WESTWINDS
995.31 ACRE TRACT
MASTER DEVELOPMEMT PLAN AMENDMENT 808-C

Re: Westwinds **MDP # 808-C**

The City Staff Development Review Committee has reviewed the Westwinds Master Development Plan **M.D.P. # 808-C**. Please find enclosed a signed copy for your files. Your plan was accepted however please note the following:

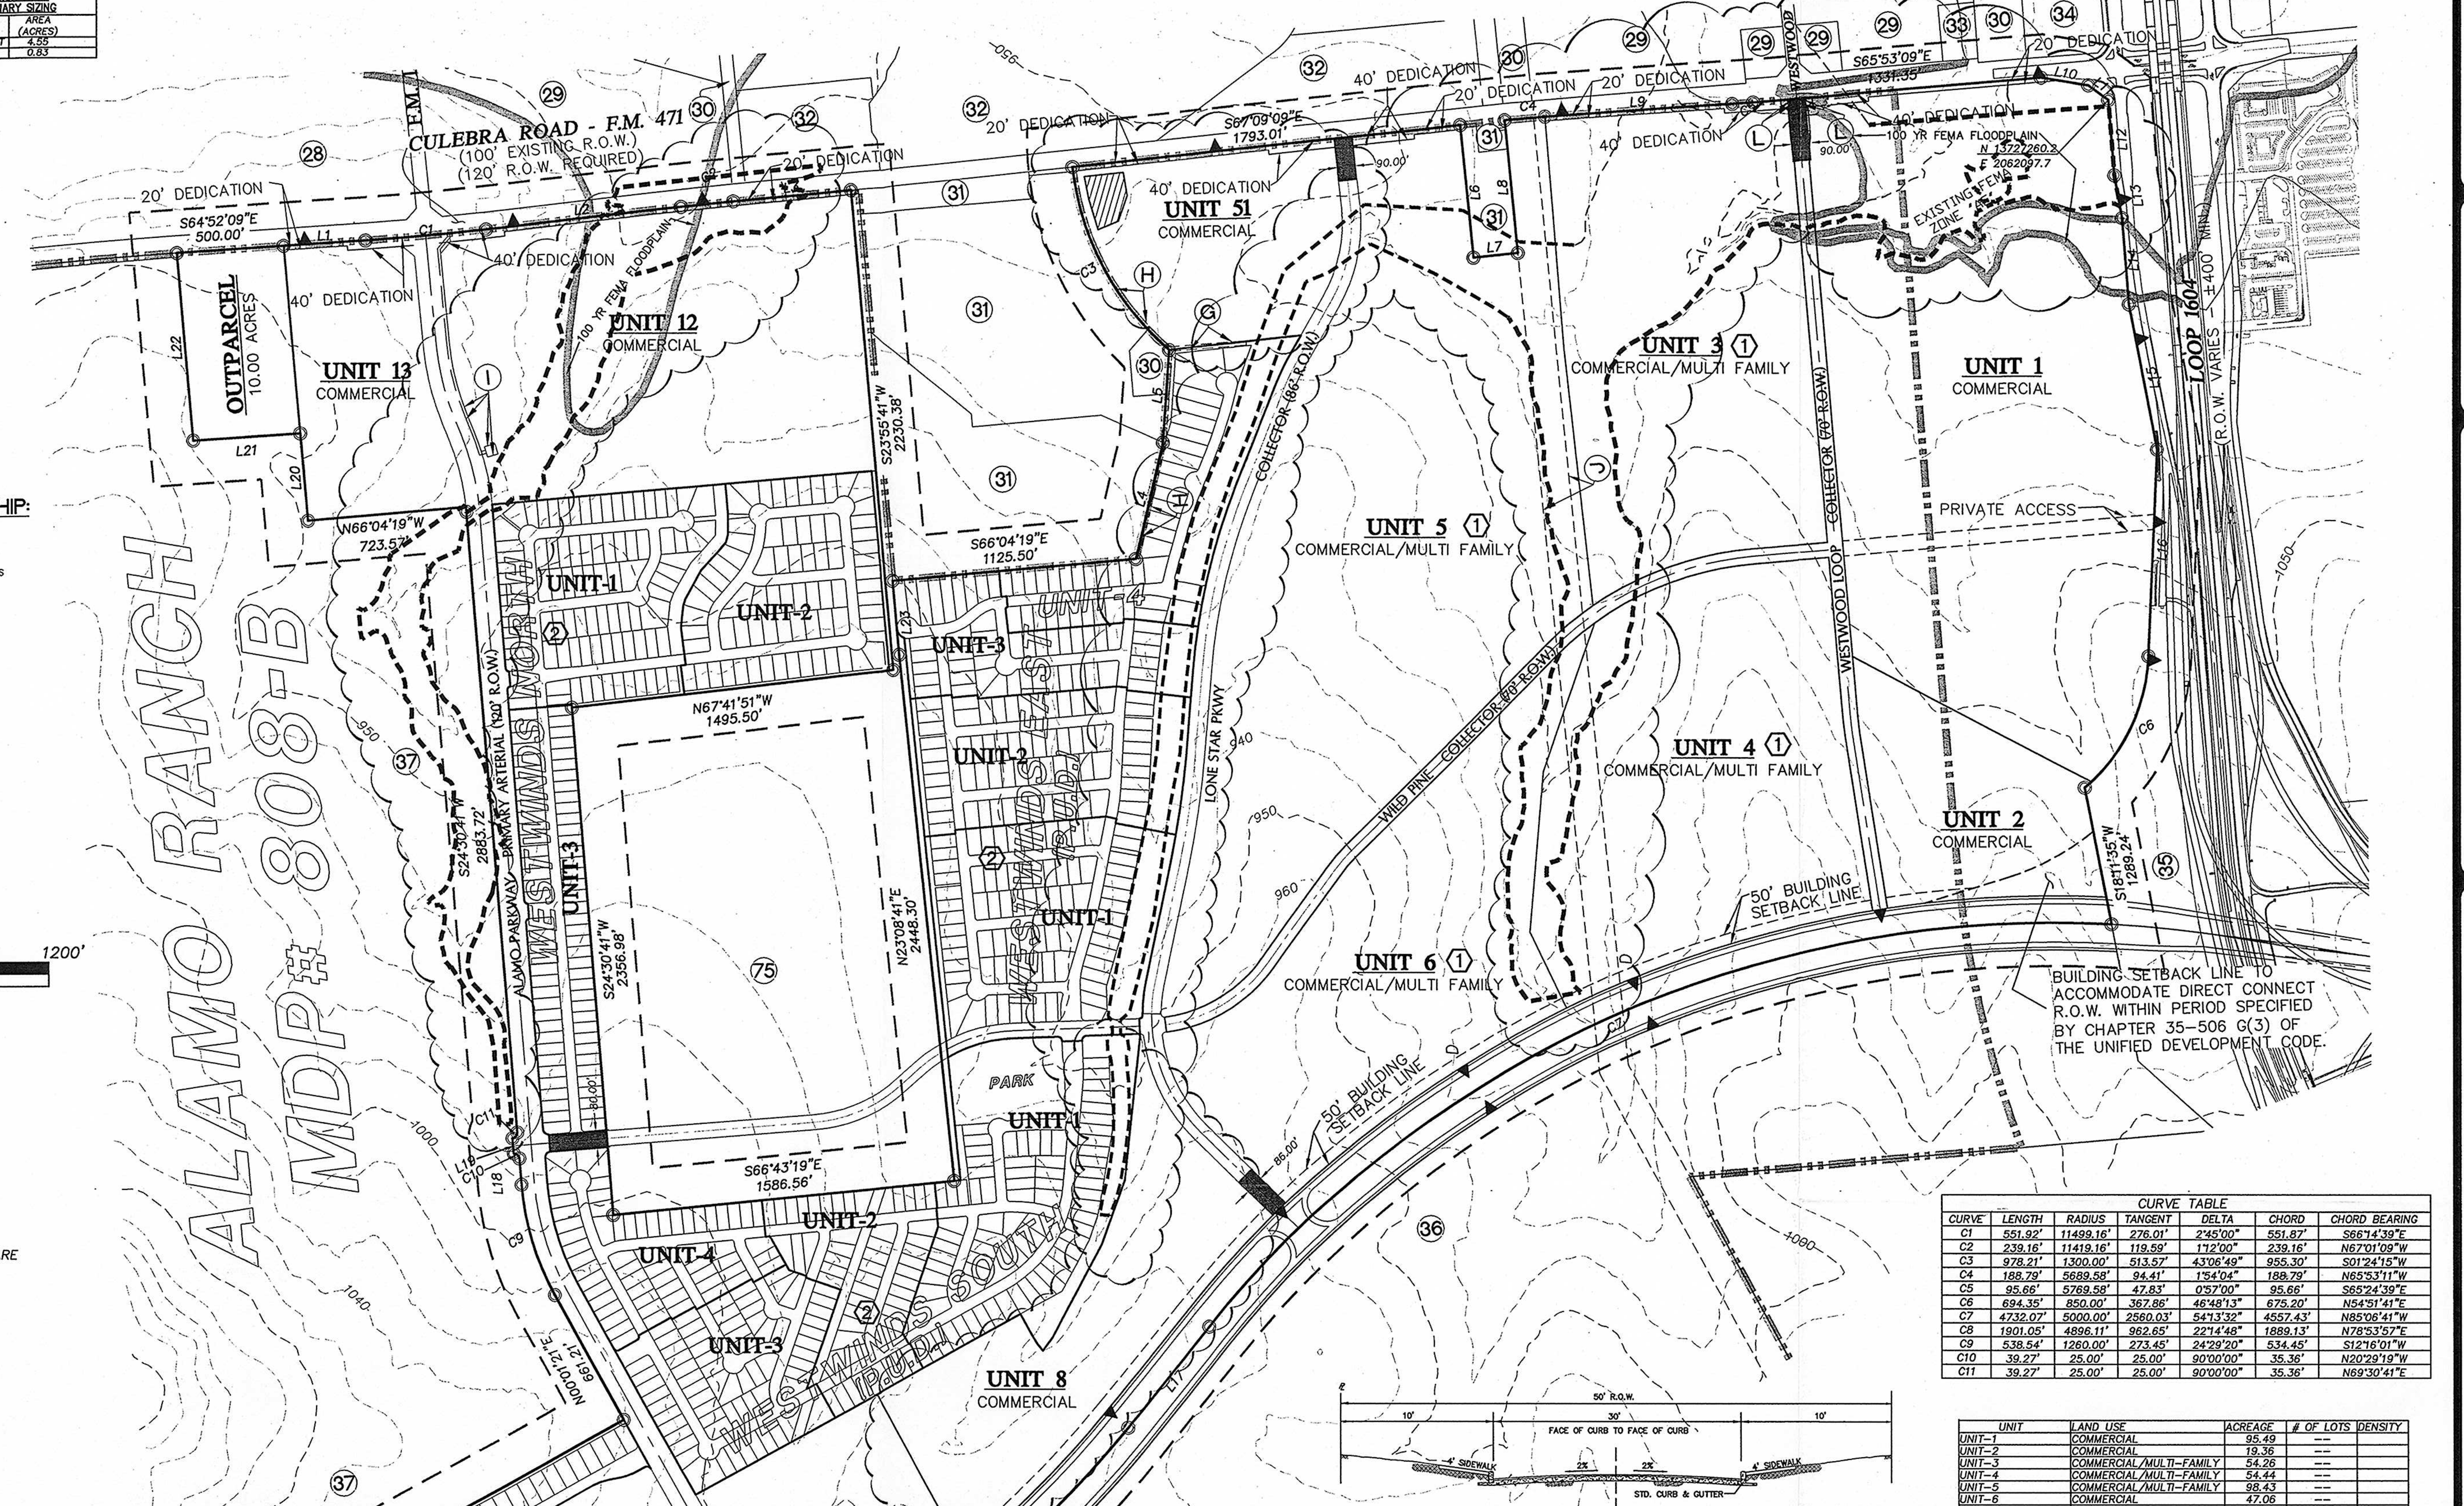
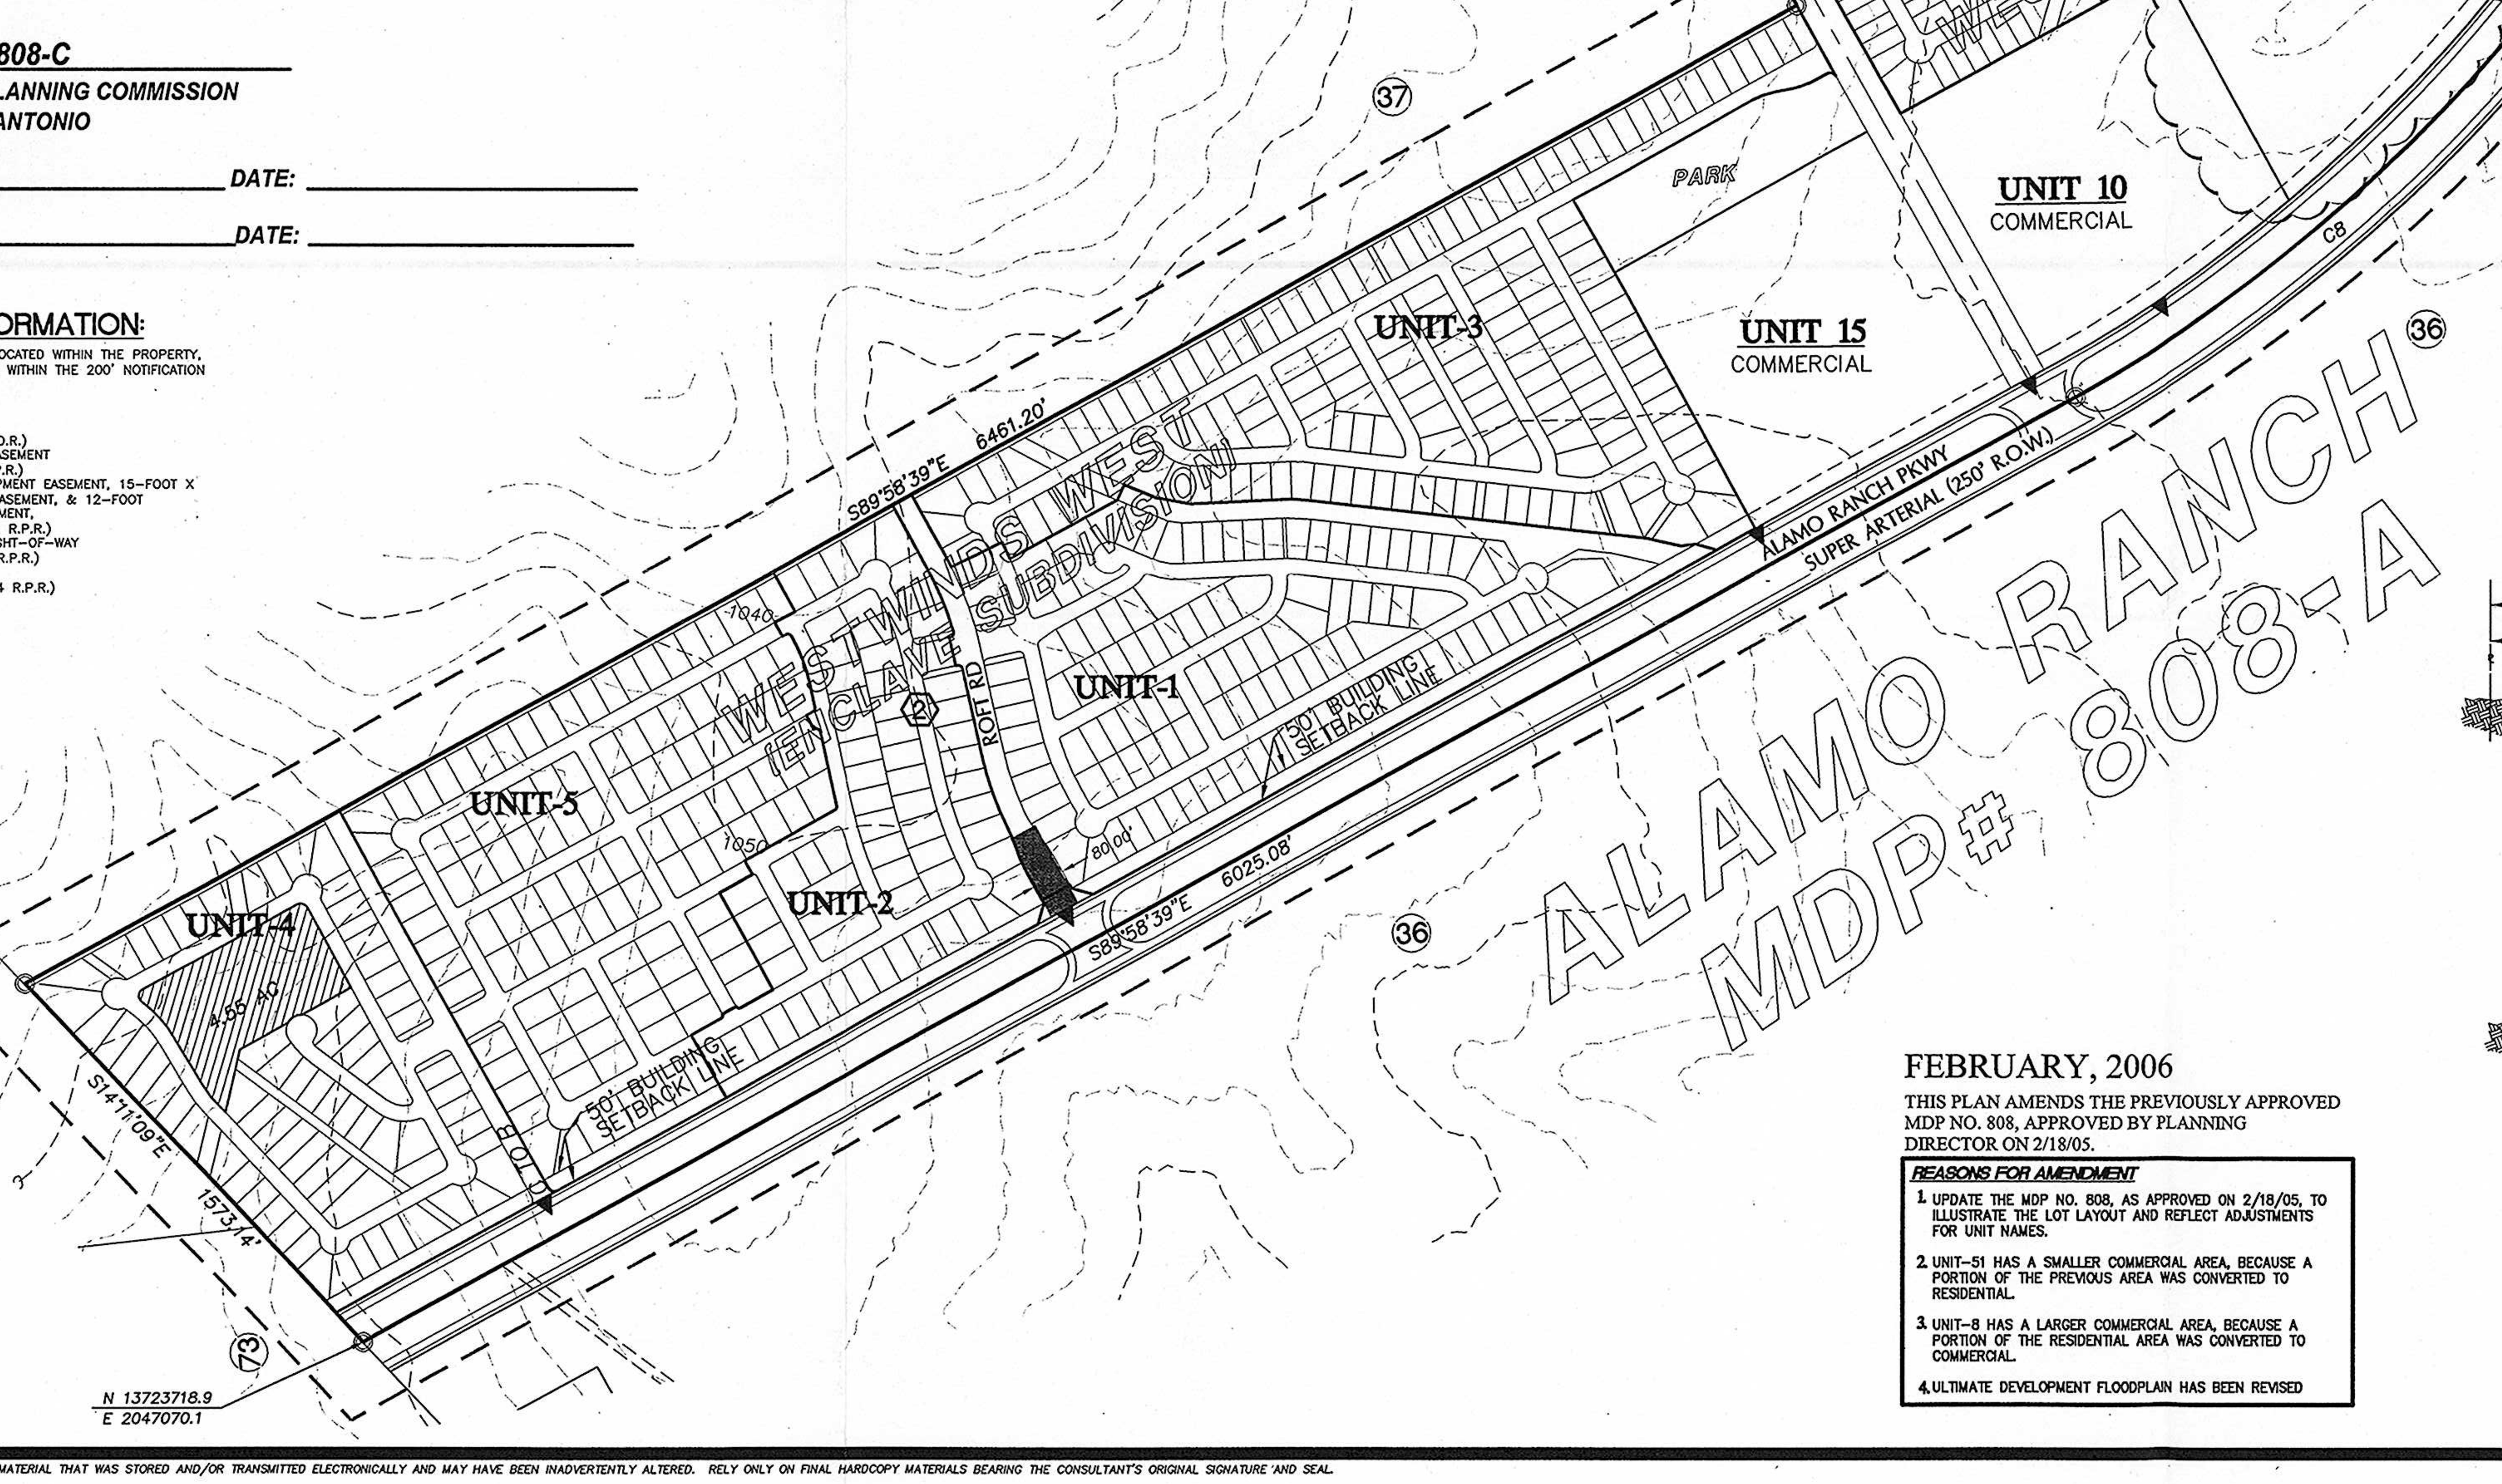
- In consideration of public safety and convenience, excessive grades by reason of topography should be avoided in street layouts and arrangements.

- Any access and R.O.W. issues along state facilities will need to be resolved with the **Texas Department of Transportation (TXDOT).** For information about these requirements you can contact TXDOT at 615-5814.

- **DSD – Traffic Impact Analysis & Streets** indicates the that the following requirements and onsite improvements are necessary and shall be provided by the developer, on and before the completion of the Westwinds MDP, at no cost to the City of San Antonio:

- All roadways shall follow Table 506-7, Functional Classification System Description and shall comply with UDC 35-502(a)(9)

- All access roadways shall provide clear sight distance on all existing and proposed roadways in order to provide adequate obstruction free viewing distances for approaching traffic. All signage, landscaping and improvements shall be selected and located so as to not block these clear sight distance areas.

- The developer shall be responsible for providing right-turn deceleration lanes as well as left turn lanes, with storage lengths and bay taper as it relates to the submitted TIA traffic counts, (Uniform Development Code (UDC) – 35-502(a)(7), subsection C.

- Sidewalks along all interior and exterior roadways are to be installed in accourdance with UDC 35-506(q).

- Intersections will require mitigation for a traffic signal (when warranted and approved by Bexar County Traffic, Public Works – Traffic and TxDOT) as per UDC 35-502(a)(7)(C) Limitations on Traffic Impact Analysis. Lane configuration of all intersection shall follow Table 14 in the Level 3 Seale Ranch TIA dated September 24, 2004.

- **Trees** approves with the following conditions:
    - 2003 Tree Preservation ordinance standards per UDC 35-523 – a Tree Preservation Plan is required prior to any work on site. This can be submitted either as a site work permit or at the platting stage.

- Streetscape Standards per UDC 35-512 – Alamo Ranch parkway requires streetscape on existing ROW. New ROWs within subdivision (Wild Pine, Lone Star Parkway, Texan Parkway, Alamo Parkway, Westwood Loop) will require streetscaping as well (we recommend preservation of existing trees where available and possible).

- **Parks** recommends approval with the following conditions:
    - The multi-family portions of this development submit detailed plans at time of platting in order to determine their park dedication requirement.

- The Park/Open Space is dedicated to their respective Home Owners Associations and a Provision and Maintenance plan be submitted to this department at time of platting.

- The areas dedicated are labeled as either "Park" or "Open Space" at time of platting.
- It will be expected that you will plat all of the property depicted in your Master Development Plan (M.D.P.) to include floodplains, drainage areas and open space.
